Application Number: 10/824,915
Filing Date: April 15, 2004
Appellant(s): SELLE, STEPHEN

EXAMINER'S ANSWER

► Claims 1 and 3-11 stand rejected under 35 U.S.C. 103(a) as being obvious over Applicant's admission of prior art, in view of either Selle US-6,640,968 or Liestner US-6,209,722.

Examiner's reasonably broad interpretation of Bursk et al. US-4,352,258.

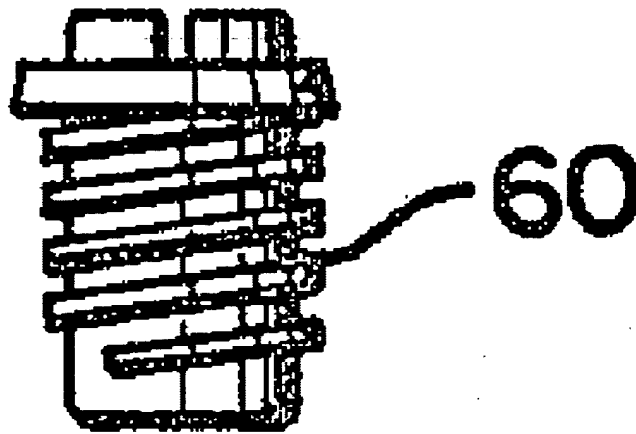
Applicant's argument that the rectangularly-shaped nut taught by Bursk et al. is not constrained against rotation by the channel of the threshold is not persuasive. Threshold (H) has a channel (I), in which at least the raised crown (T) and interior threads (U) of the rectangularly-shaped nut (B) reside in. Since the nut (B) is rectangularly shaped and has two faces held against rails of threshold (H) forming the channel (I), it is held in non-rotatable fashion in said channel (I).

Examiner's reasonably broad interpretation of Selle US-5,993,320.

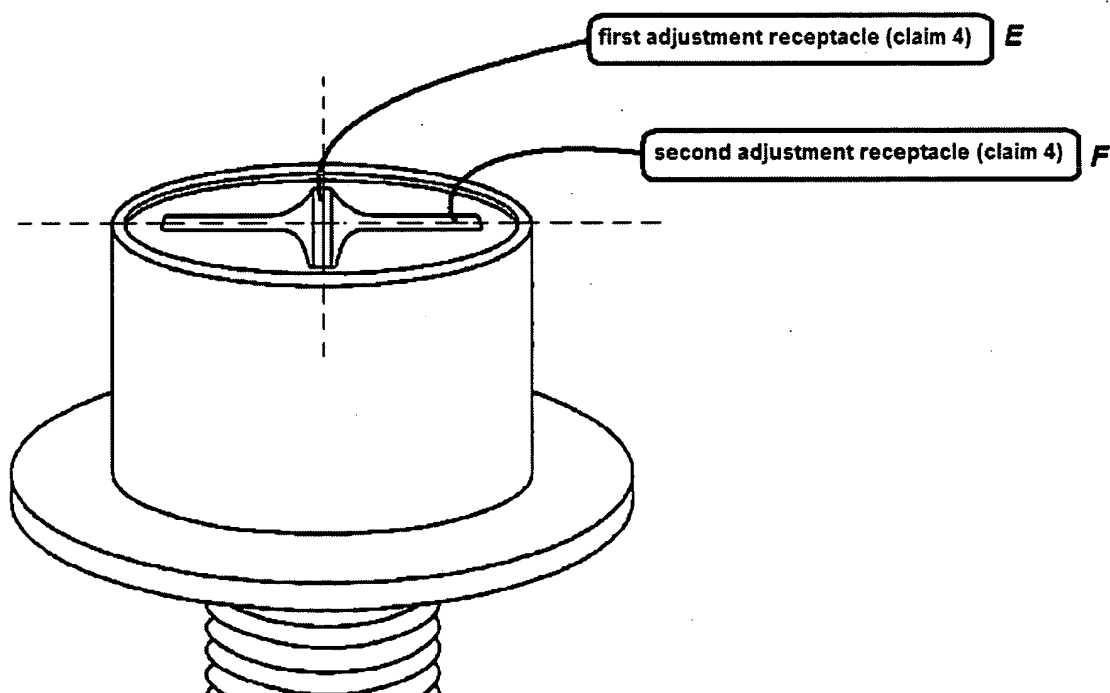
As indicated in the above rejection, Examiner disagrees with Applicant that Selle fails to include a head guide and a flange guide. It was stated to Applicant in the final rejection mailed on 31 October 2005 that the examiner has interpreted claim 11 as not positively reciting the "fastener", "threaded stud", "support head", "U-shaped nuts", and "rearward and forward flanges". However, claim 11 does positively recite "a curvilinear delivery track", "a head guide",

and "a flange guide -- all of which are taught by Selle US-5,993,320 (see below drawing). The preamble of claim 11 states that the intended use of the curvilinear delivery track is "for delivering a plurality of fasteners..." and then goes on to recite certain structural features of said fasteners, and how they would interact with the curvilinear delivery track when "said head guides of said delivery track engage said support heads of said fasteners" and when "said support heads of said fasteners [are] in combination with said head guide". Examiner acknowledges Applicant's statement that "the claim lacks a positive recitation of the threaded stud having support head is correct".

Examiner's reasonably broad interpretation of Mettler US-6,185,870

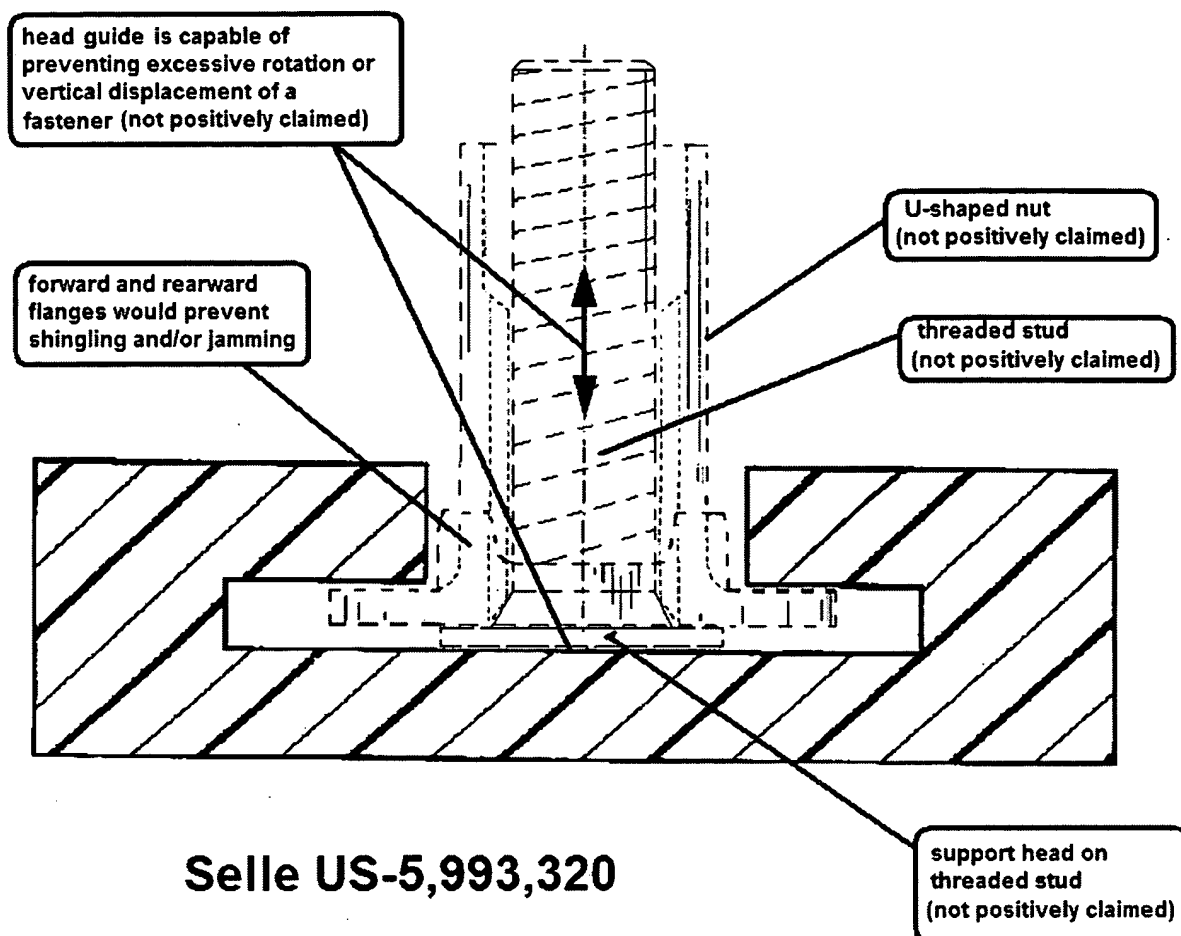
Applicant's argument that Mettler US-6,185,870 does not include two adjustment receptacles as claimed is not persuasive. Mettler clearly shows two adjustment receptacles (E) and (F). The purpose for providing a second adjustment receptacle is to allow both a flat head screwdriver, AND a Phillips head screwdriver to adjust the threaded stud.
